ECE/TRANS/WP.29/GRSG/2009/6  
23 February 2009

**REGULATION No. 118  
(Burning behaviour of materials)**

**Proposal for draft amendments to Regulation No. 118**

**Submitted by the experts from France and Germany\*/**

**Figure 4**  
**Apparatus for testing the capability to repel fuel or lubricant**  
**(Dimensions in millimeters)"**

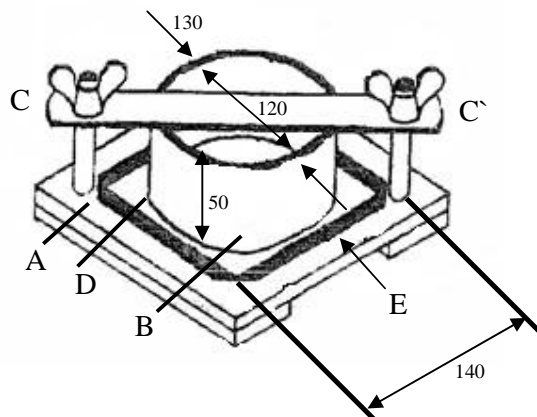
Insert a new Annex 9, to read:

**This annex lists prescriptions to test the capability of insulation materials used in engine compartments and separate heating compartments.**
- 2.       **Sampling and principle**
  - 2.1.      **The test samples shall measure: 140 mm x 140 mm. The thickness of the sample corresponds to the thickness of the product to be tested.**
  - 2.2.      **Four samples shall undergo the test.**
- 3.       **Apparatus (see figure 4)**

- A a base plate with an absorbant surface (e.g. paper);
- B a metal cylinder (inner diameter of 120 mm, outer diameter 130 mm, height of 50 mm), filled with the test medium;
- C - C` two screws with wing nuts;
- D the test sample;
- E a seal plate, with an hardness of 70 Shore D.
